Submit I Copy To Appropriate District Office	State of New Mexico			Form C-103	
District I- (575) 393-6161	Energy, Min	nerals and Natu	ral Resources	WELL API NO.	Revised July 18, 2013
1625 N. French Dr., Hobbs, NM 88240 District II- (575) 748-1283	OH CONGERNAL MICH DAVIOUS			30-015-32750	
1301 W. Grand Ave., Artesia, NM 8821 0	OIL CONSERVATION DIVISION			5. Indicate Type	of Lease
<u>District III</u> - (505) 334-6178 1 000 Rio Brazos Rd., Aztec, NM 8741 0	1220 South St. Francis Dr.			STATE	⊠ FEE □
District IV- (505) 476-3460	Santa Fe, NM 87505			6. State Oil & G	as Lease No.
1220 S. St. Francis Dr., Santa Fe, NM 87505				V-6501	
SUNDRY NOTICES AND REPORTS ON WELLS				7. Lease Name o	r Unit Agreement Name
(DO NOT USE THIS FORM FOR PROPOSALS TO DRILL OR TO DEEPEN OR PLUG BACK TO A DIFFERENT RESERVOIR, USE "APPLICATION FOR PERMIT" (FORM C-101) FOR SUCH				Tigan State	
PROPOSALS.)				Tiger State 8. Well Number 2

13. Describe proposed or completed operations. (Clearly state all pertinent details, and give pertinent dates, including estimated date of starting any proposed work). SEE RULE 19.15.7.14 NMAC. For Multiple Completions: Attach wellbore diagram of proposed completion					
offreco

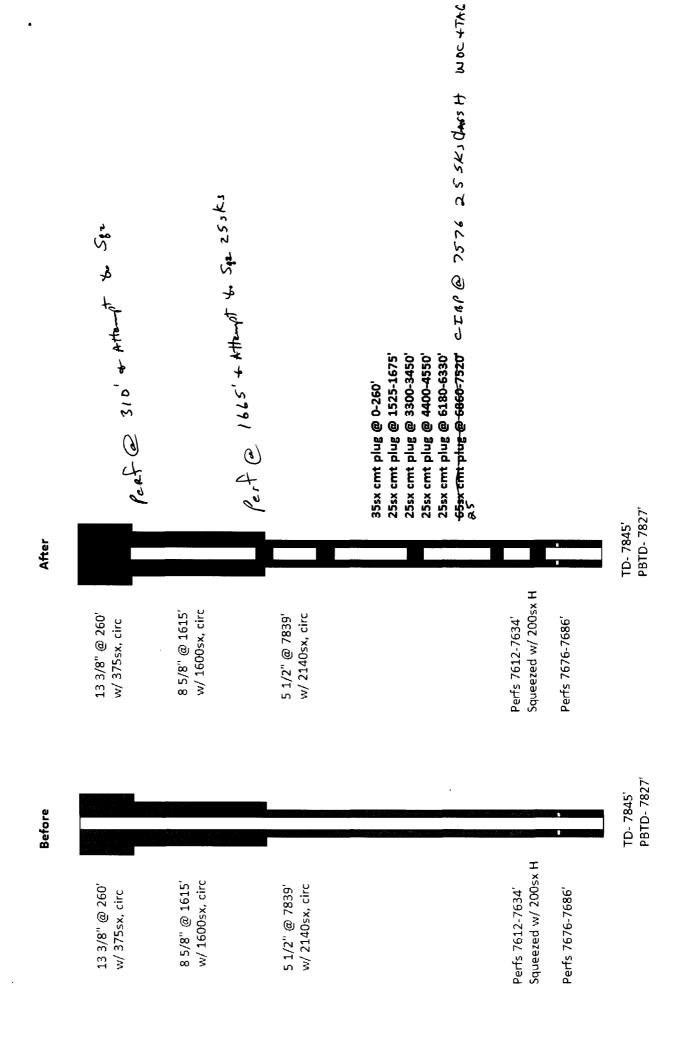
1. RIH with tubing. Set 65sx cement plug from 7520-6869. WOC and tag plug ARTESIA DISTRICT 2. Set 25sy compart plug from 6230, 61801					
2. Set 25sx cement plug from 6330-6180'. 3. Set 25sx cement plug from 4550-4400'. FEB 2 2 2018

4. Set 25sx cement plug from 3450-3300'. WOC and tag plug.					
5. Set 25sx cement plug from 1675-1525'. WOC and tag plug. Perf @ 1665' Sq z					
6. Set 35sx cement plug from 260-0'. Perf @ 310 Sez Approved for plugging of well bore only.

7. Install Dry Hole Marker.		•	1	bond is retained pendi	
Note: Mud laden fluids mixed at 25 sacks of gel per 100 barrel of 9.5 par be found at OCI Web Page under water shall be placed between all plugs.					
Note: Mud laden fluids mixed	at 25 sacks of get	per 100 barrei o	19.3 ppg Brine W	nrd.state.nm.us/ocd.	d between all plugs.

Spud Date:		Rig Release Da	te:		
	// / /	6			
* See ATTAChed	COAS		Must be	= Plugged	64 2-22-19
I hereby certify that the information above is true slid complete to the best of my knowledge and belief.					
None Allegan					
SIGNATURE L WILLIAM	DINHI	TITLE Product	ion Clark	т.	ATE 2/21/18
SIGNATURE JUM W	CVCVCV	_ HILE Floader	IOH CIEIK	D	ATE <u>2/21/18</u>
Type or print name Deana Weaver		E-mail address	dweaver@mec.	com p	HONE: 575-748-1288
For State Use Only		-

APPROVED BY: DATE 2-22-18
Conditions of Approval (if any):
